## **AMENDMENTS TO THE DRAWINGS:**

**REMARKS**

## Appendix A

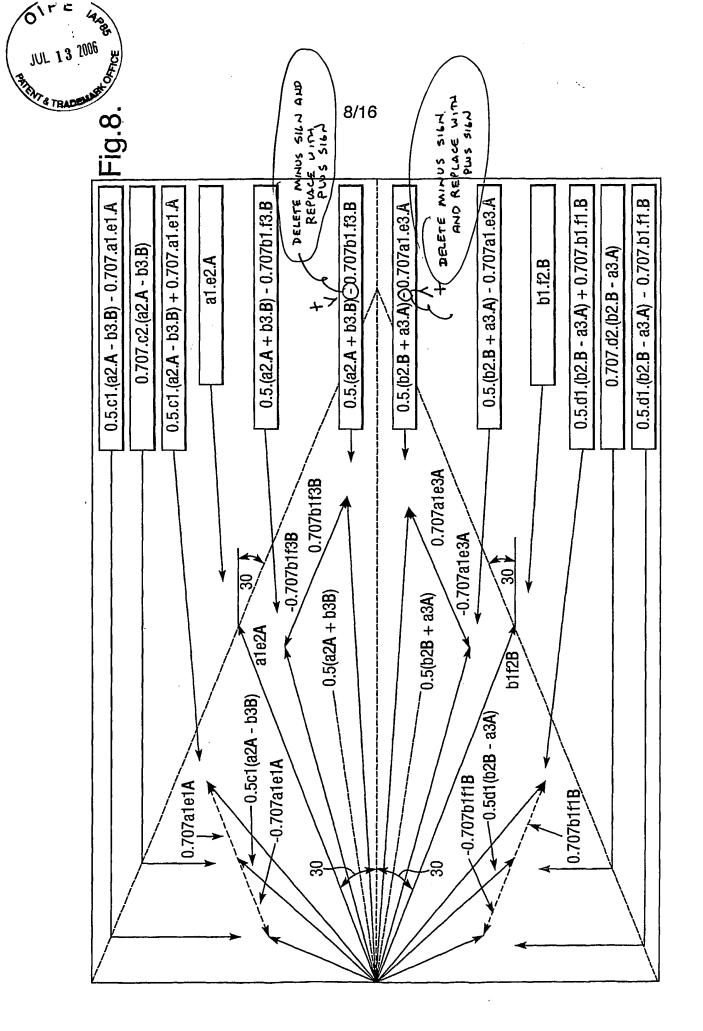
The attached drawing sheets include amended and marked-up versions of Figure 8. Figure 8 has been amended to change several minus (-) signs to plus (+) signs.

Figure 8 is amended in two instances to change minus signs ("-") to plus signs ("+").

This amendment is supported by vector diagrams (arrows indicating vectors in magnitude and

direction) adjacent to the left side of the amended Figure 8 boxes, which show 0.707b1f3B being

added to 0.5(a2A + b3B) and 0.707a1e3A being added to 0.5(b2B + a3A) respectively.
